VILLAGES AT STERLING RANCH

CONSTRUCTION PLANS

NOVEMBER 2024

V1_Construction Drawings (Plans-Profiles).pdf Markup Summary

PUBLIC STORM PLANS
OAK PARK DRIVE

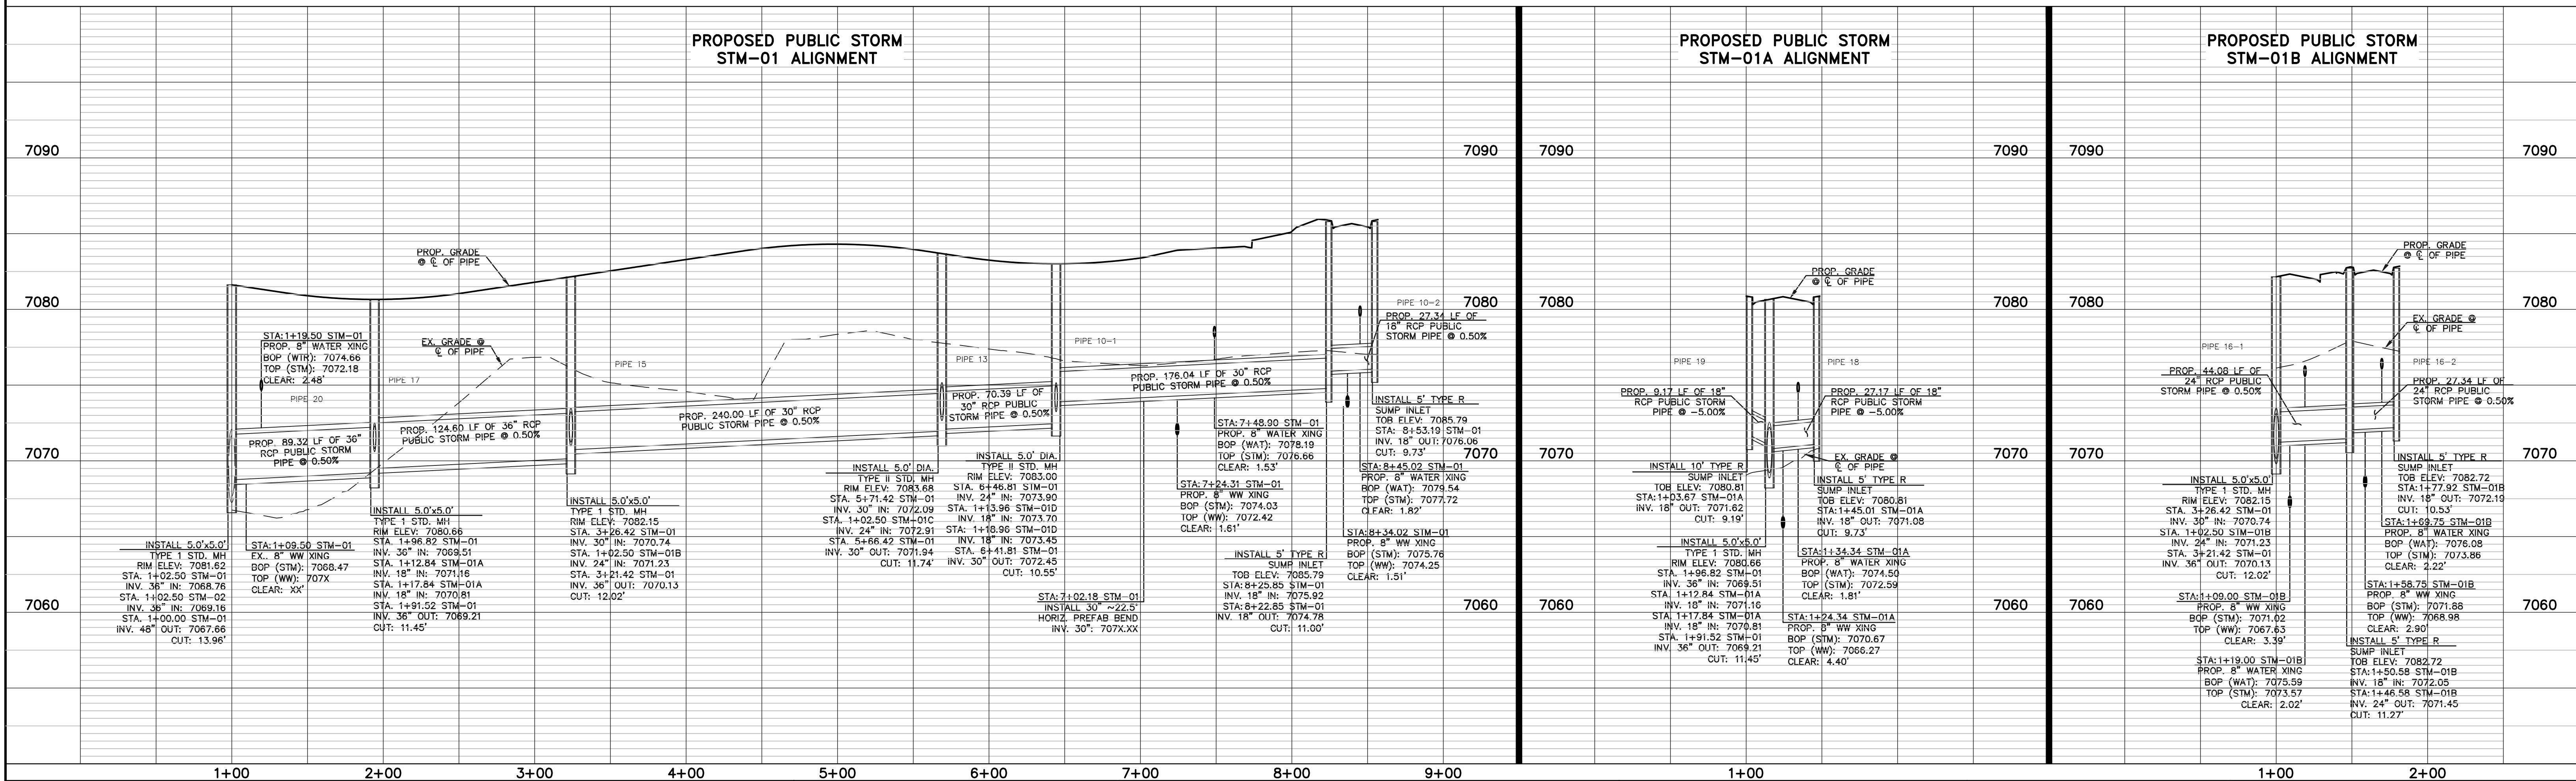
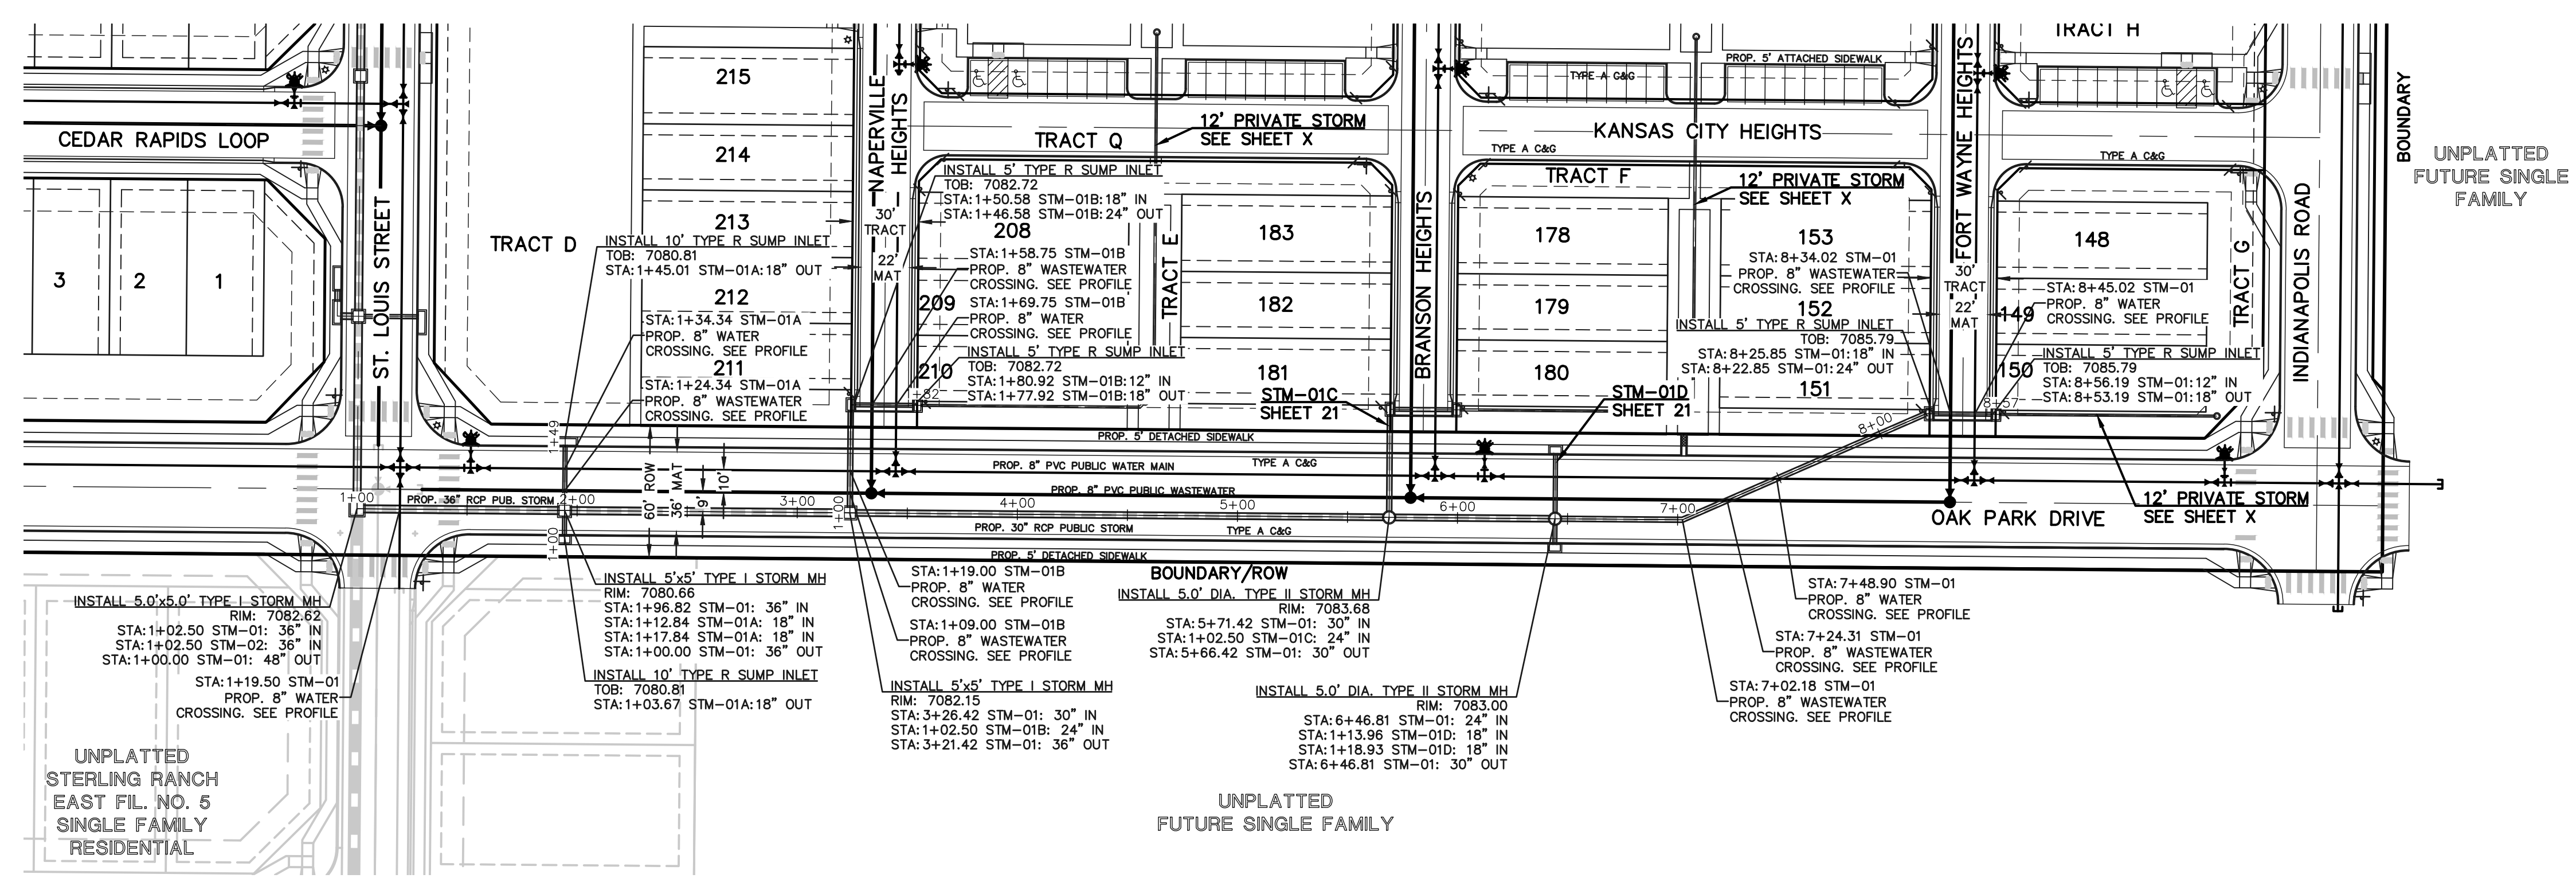
Storm Plans will be reviewed when storm design & HGL calculations have been provided in final drainage report.

DATE APPROVED: 9/16/10	Storm Sewer Manhole Details Standard Drawing	
APPROVED BY: André P. Brackin	REVISION DATE: 9/16/10

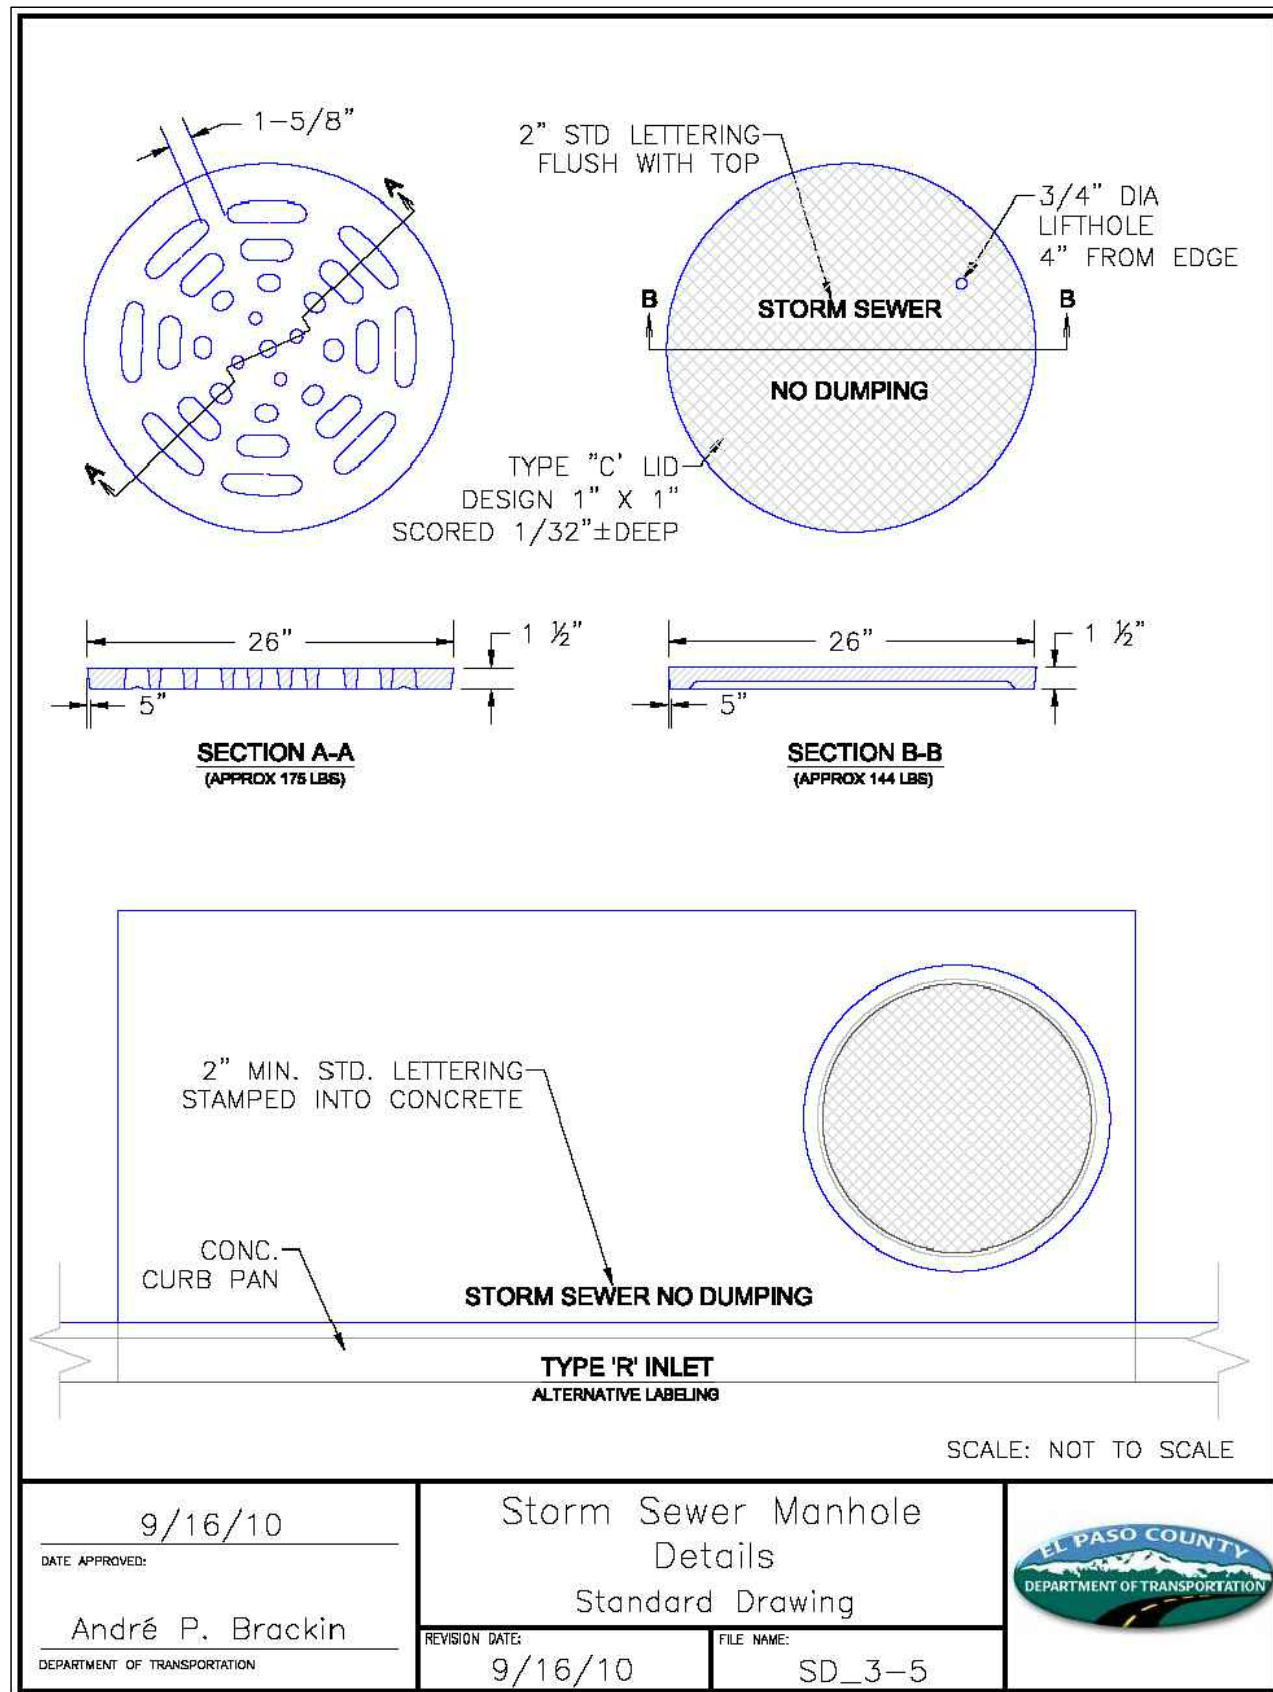
Include detail for area inlet
